date:	5.24.24
project:	Nibley Middle School
by:	Michael Rigby
subject:	Addendum 04

CONTRACT ADDENDUM 04

PLAN - LEVEL 01 - AREA A - FINISH

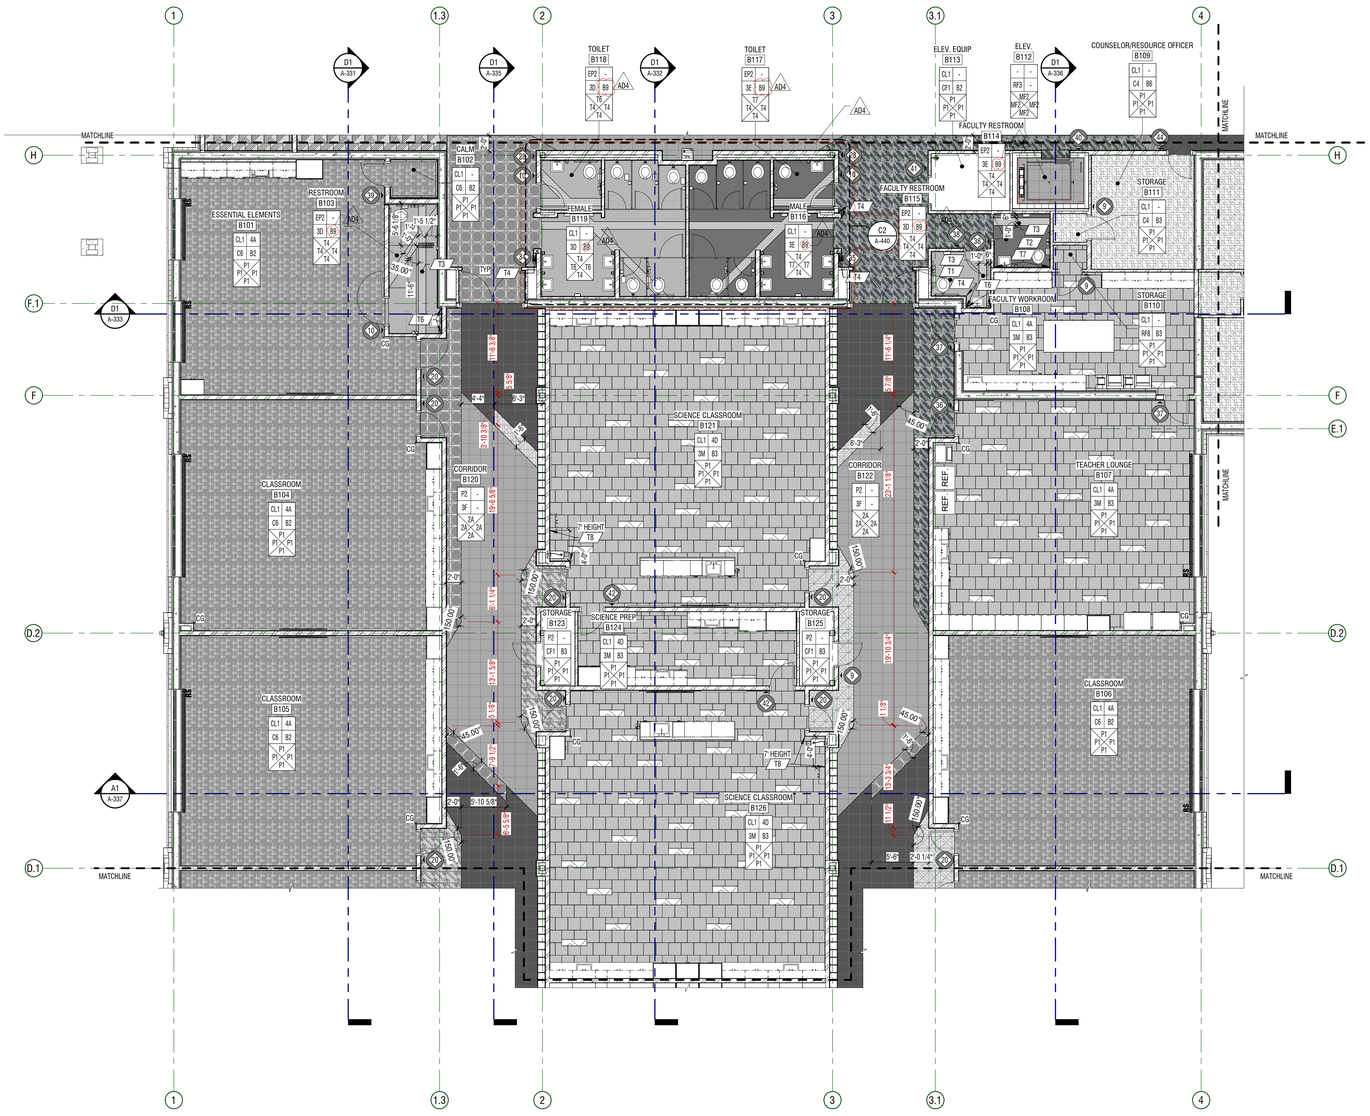
04.02 A-111.3 – PLAN – LEVEL 01 AREA A - FINISH
- Added enlarged view callout of restrooms

PLAN - LEVEL 01 - AREA B - FINISH

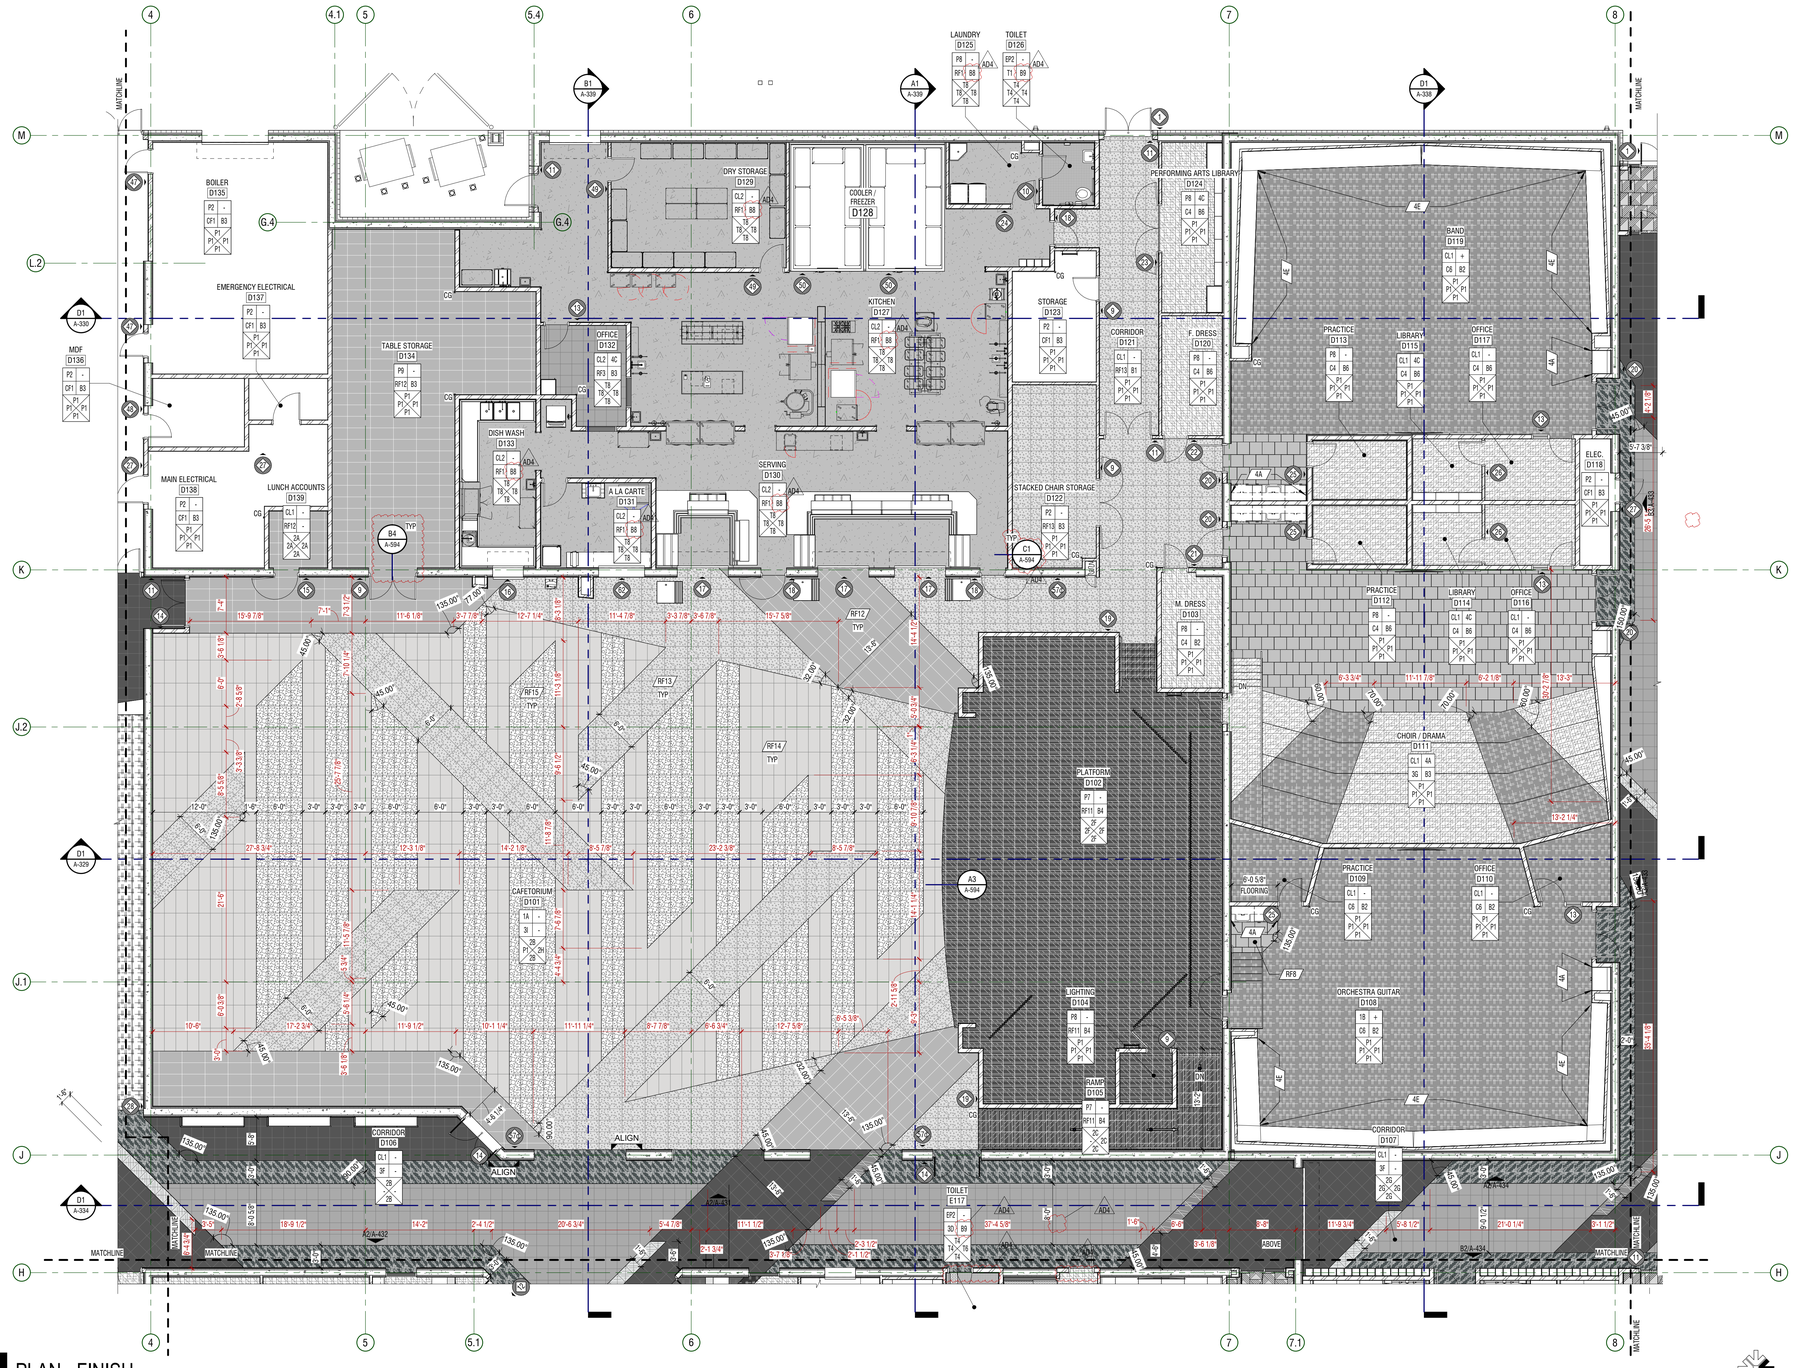
04.03 A-112.3 – PLAN – LEVEL 01 AREA B - FINISH
- Updated base in finish tags B103, B119, B116, B115, and B114
- Added enlarged view callout of restrooms

PLAN - LEVEL 01 - AREA E - FINISH

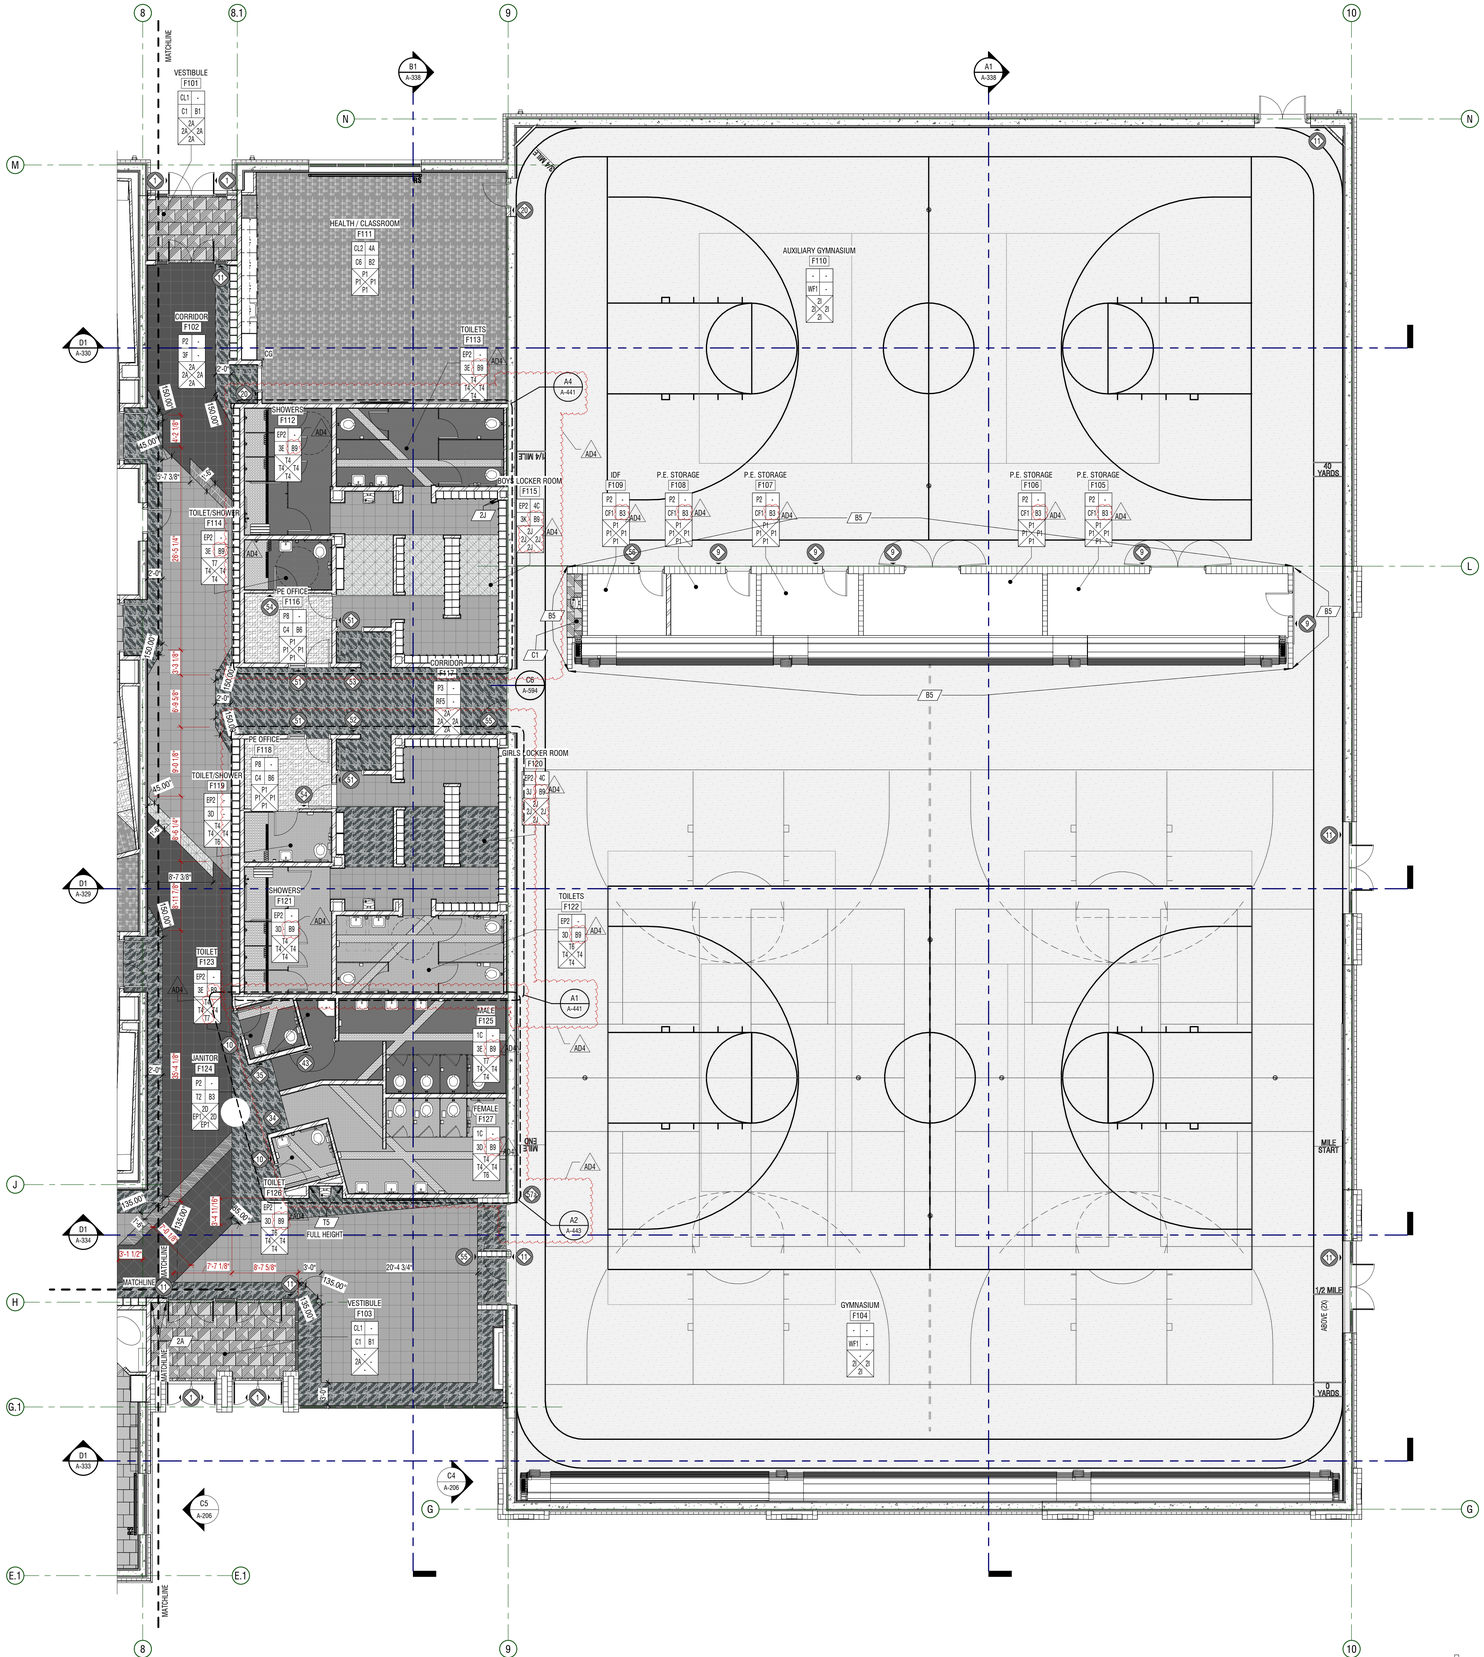
04.05 A-115.3 – PLAN – LEVEL 01 – AREA E – FINISH
- Adjusted flooring hatch in Toilet E117 and Corridor E120
- Added finish tag to Toilet E117
- Updated base in finish tags E117 and E120

PLAN - LEVEL 01 - AREA F - FINISH

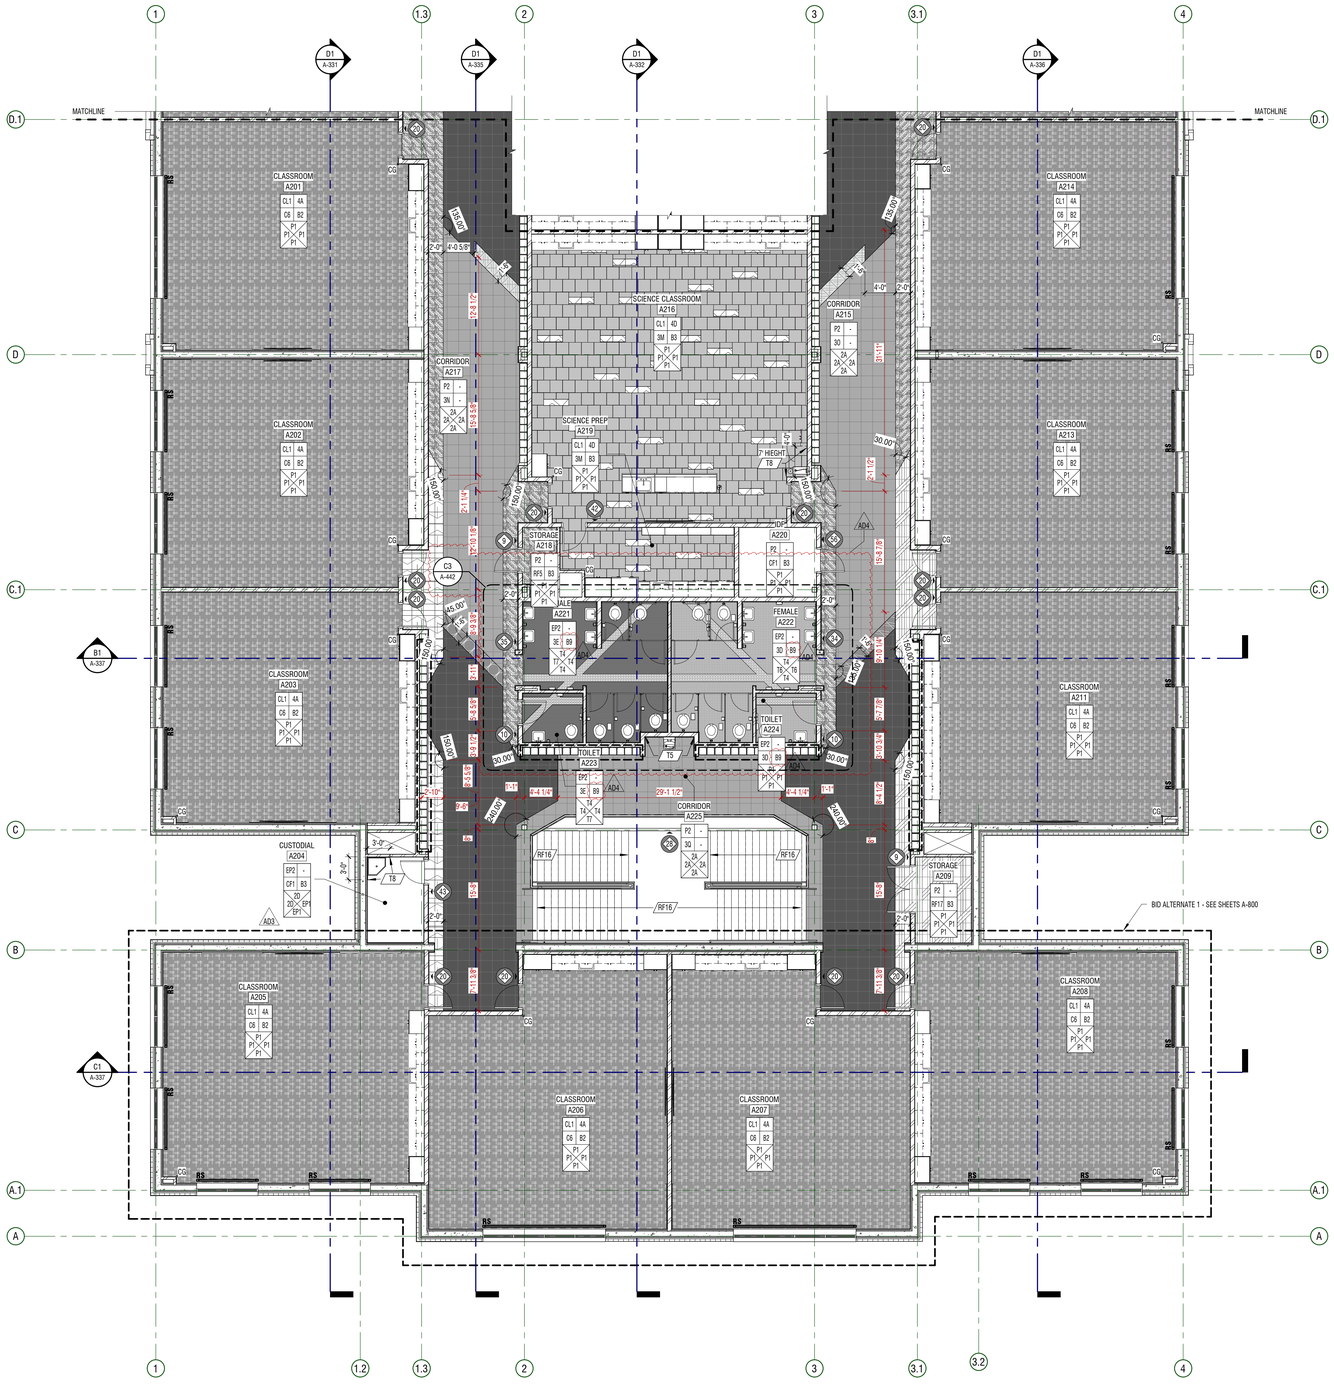
20 **FLOORING QUESTION 15:** *F105-F109 Storage closets show B5 Vented cove. These areas are CF1 floor finished. Should these areas receive standard B3 rubber base in lieu of the vented cove that goes on the gymnasium flooring?*

04.06 A-116.3 – PLAN – LEVEL 01 – AREA F – FINISH
- Updated base in finish tags F109, F108, F107, F106, F105, F21, F122, F123, F125, F126, F127, F112, F113, F114,
- Updated walls and base in finish tags F115 and F120
- Created enlarged views of restrooms and lockers – see callout
- Updated finish tag in Janitor F124
- Removed marker elevations

ANSWER: Yes, these areas should have B3 Rubber base. This has been updated in addendum.

PLAN - LEVEL 02 - AREA A - FINISH

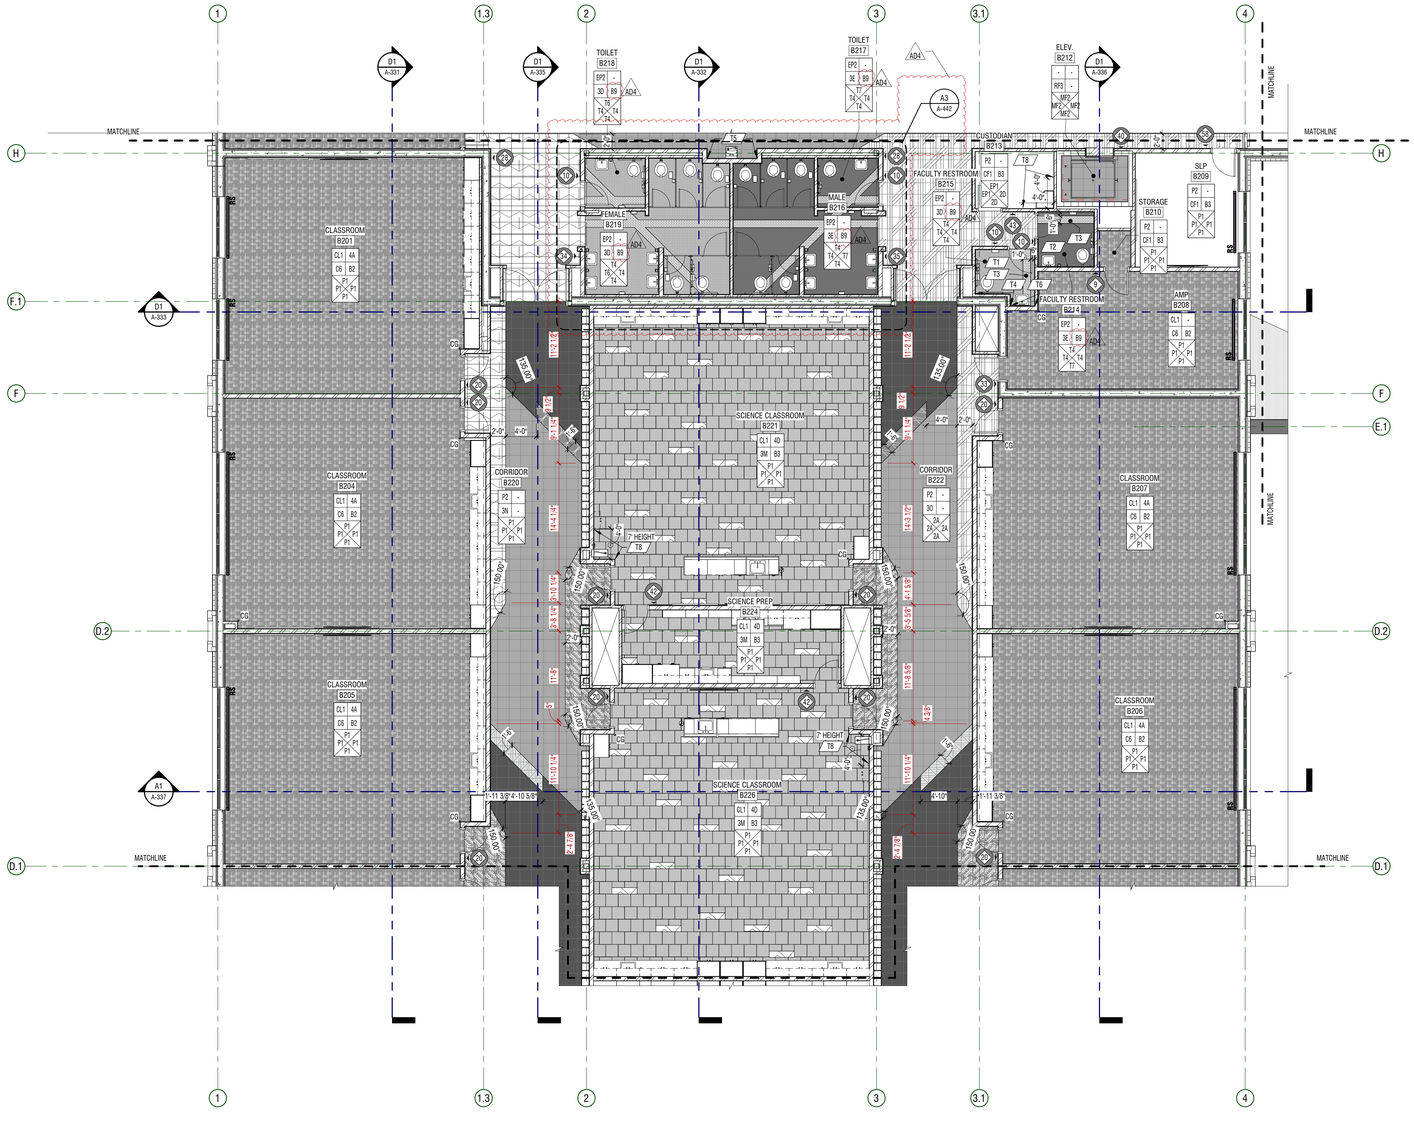
04.07 A-121.3 – PLAN – LEVEL 02 – AREA A – FINISH
- Added enlarged view callout of restrooms – see callout
- Updated finish room tag A221, A222, A223, A224,

E1 TYPICAL TILE PATTERN

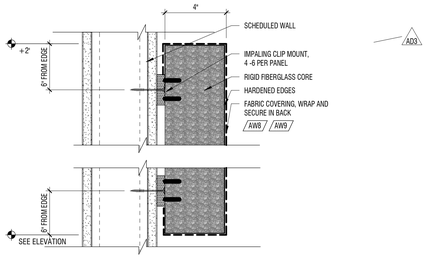
18 **FLOORING QUESTION 13:** *Is there any elevations available for the kitchen walls?*

ANSWER: No, see updated T8 on sheets A-591 - N and A-591 - H and E1/A-594. These have been updated in addendum.

C1 RESILIENT TO TILE BASE DETAIL

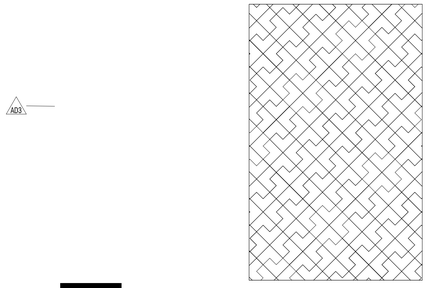
17 **FLOORING QUESTION 12:** *Specifications 096516-2 2.01 Basis of Design B Shows 6" Cove base system for the kitchen Protect-All flooring. Plans show wall tile on all walls in the kitchen area. Please confirm if Protect-All cove base is needed in kitchen area.*

ANSWER: Yes, Protect-All cove is needed see detail C1/A-594. This has been updated in addendum.

B1 TYPICAL UCS BASE DETAIL

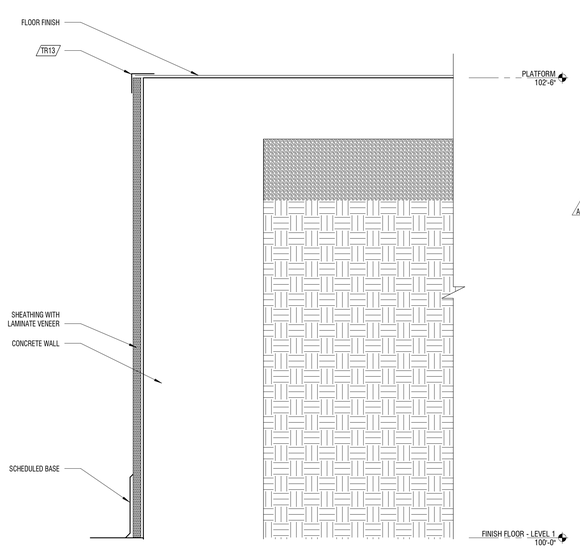
19 **FLOORING QUESTION 14:** *At all C1 Entry Carpet locations it calls out 6" Rubber base. Is it the intent to install the 6" rubber base on top of the Dekton Impace resistant materials where applicable? Or does the Dekton go on top of the 6" which would then present a transition issue where the corridors meet the entries.*

ANSWER: No base where there is walk off carpet and Dekton. See detail B1/ A-594. This has been updated in addendum.

B5 SCHLUTER CORNER TRANSITION

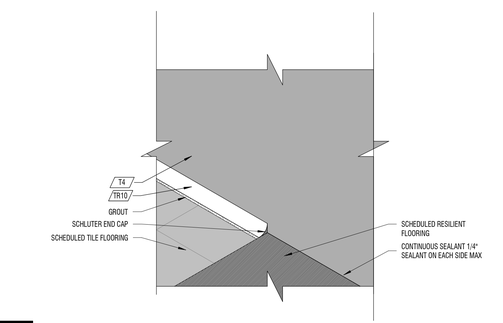
11 **FLOORING QUESTION 6:** *Where does the Dilex Terminate at the locations where it meets the Corridor Dekton at restroom/Locker room door openings? This will create an issue if the corridor T4 meets the restroom T4.*

ANSWER: See details A5 and B5 on sheet A-596, this has been updated in addendum.
